Subject: Building Permit # 2403-052
Date: Wednesday, June 5, 2024 at 7:25:51 AM Pacific Daylight Time
From: David Grubb <davidg@ghdarch.com>
To: Molly McGuire <molly.mcguire@mercerisland.gov>
Attachments: image001.png, image002.png, 2219 Seifert South Side Yard Grade.pdf

SEIFERT REMODEL
3261 67TH AVE SE
MERCER ISLAND, WA 98040

EXTERIOR ELEVATIONS
PROPOSED

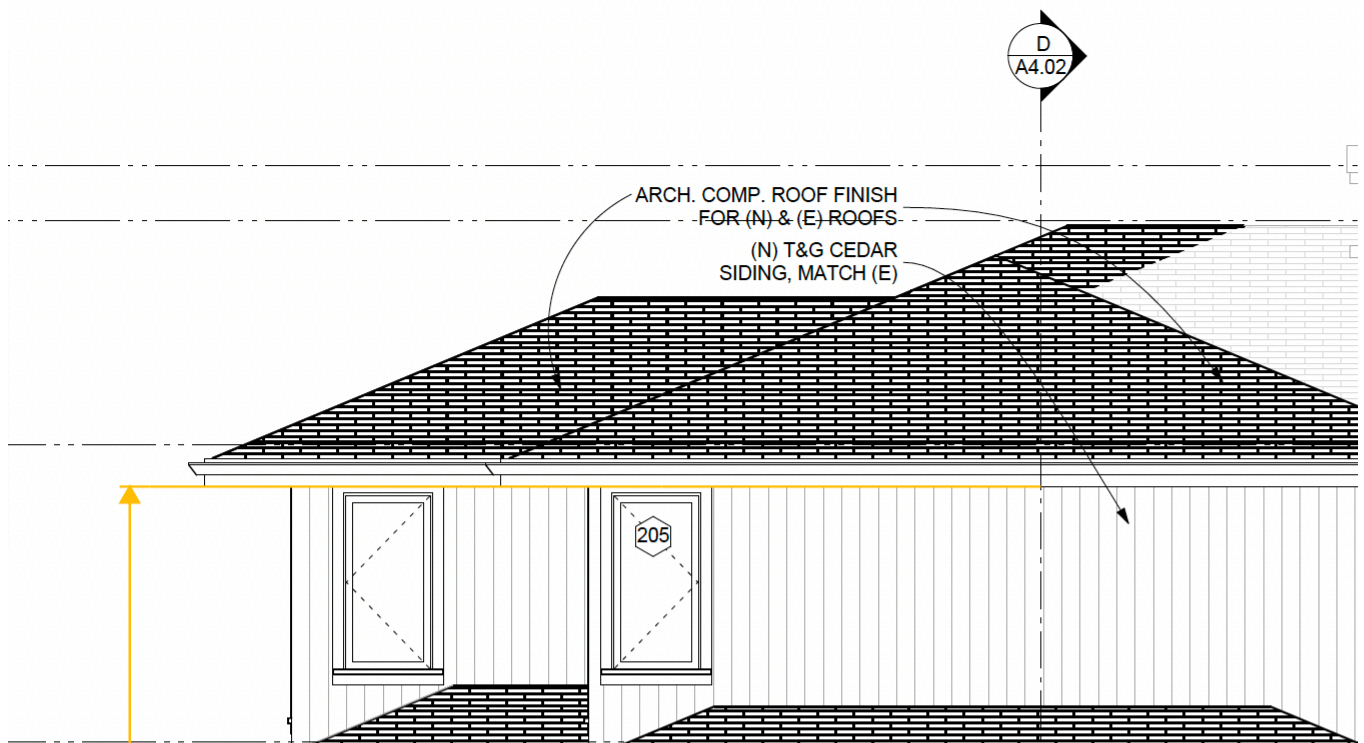
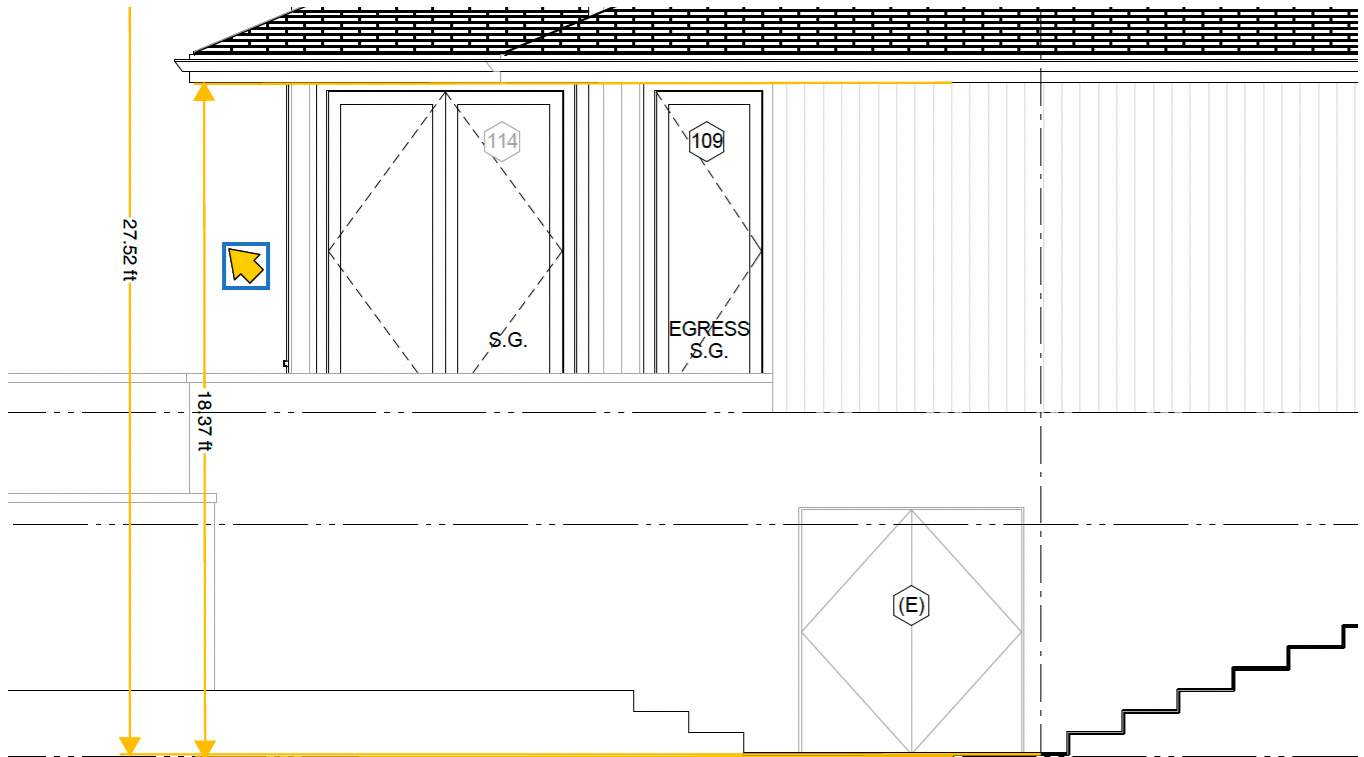
Comment #2:

“The wall facade abutting the south property line exceeds 25 feet in height and requires a 10 ft variable side yard setback per MICC 19.02.020(C)(1)(c)(iii)(b):

Single-family dwellings with a height of more than 25 feet measured from the existing or finished grade, whichever is lower, to the top of the exterior wall facade adjoining the side yard shall provide a minimum side yard depth of ten feet.

Additions in height are required to comply with all residential development standards, including all required yard setbacks. The upper story addition in this area results in an addition in height, which would require compliance with the variable side yard setback per MICC 19.01.050(D)(1)(b)(i):

...An increase in height of that portion of a structure that is legally nonconforming because it intrudes into a required yard is an increase in the nonconformity and is not allowed unless the additional height meets the current yard requirements of MICC 19.02.020(C)(1)

Because the lower portion requires a 7.5 ft side yard setback per MICC 19.02.020(C)(1)(c)(iii)(a)(1), this portion is nonconforming.”

Regarding comment #2 above: If we scale the façade height from grade that is at the south property line/directly behind the timber retaining wall it is 25' or less along the proposed upper floor exterior wall. We understand the intent of the code is to protect neighboring properties with views and massing close to property lines. As explained above, the façade height that you measured was taken from a dug out access point for crawl space. Please let me know if this is an acceptable means to comply with the side yard setback code requirement. Regarding the main floor exterior façade height. We are not proposing any increase in height to the existing main floor exterior wall/plate heights. We are simply removing the

necessary portions of the existing roof structure to allow of the new upper floor addition and reroofing all existing roof areas that remain.

NE1/4, SE1/4, SEC 11, TWP 24N, RNG 4E, W.M.
BOUNDARY & TOPOGRAPHIC SURVEY

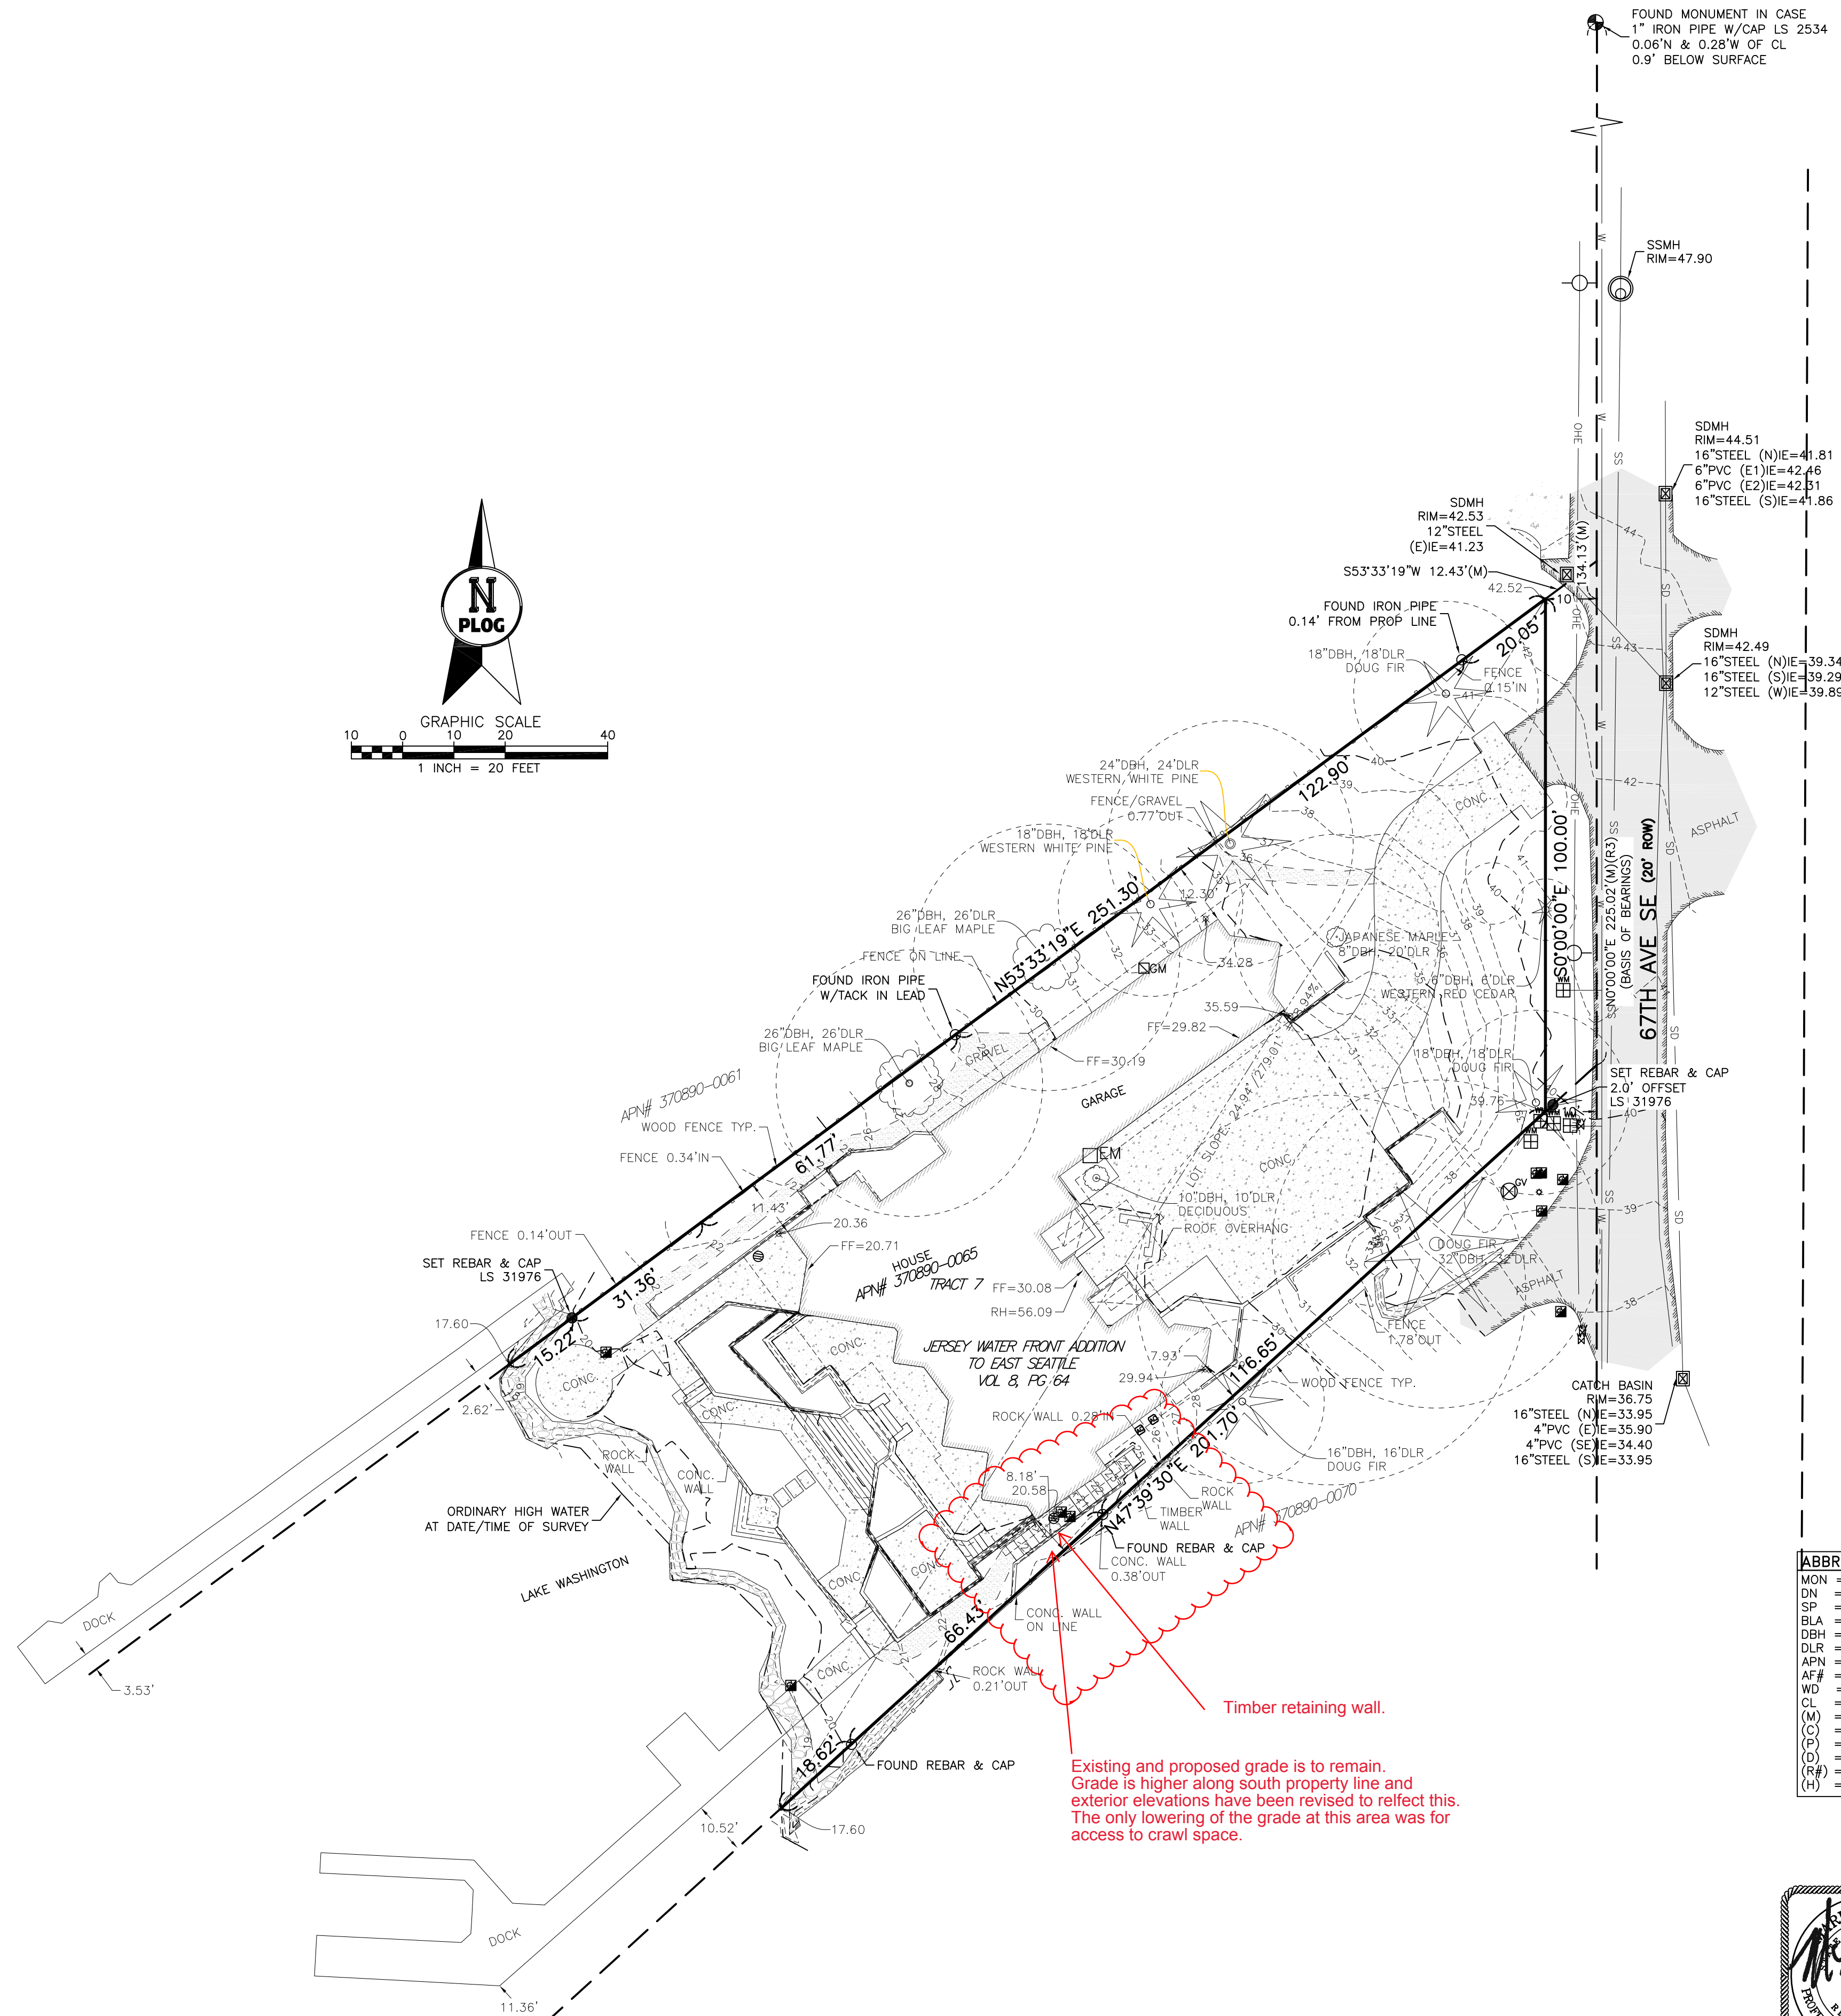
“Show existing and finished grades in relation to the basement on all elevation drawings to verify basement exclusion calculations.

Timber retaining wall.
Existing and proposed grade is to remain. Grade is higher along south property line and exterior elevations have been revised to reflect this. The only lowering of the grade at this area was for access to crawl space.
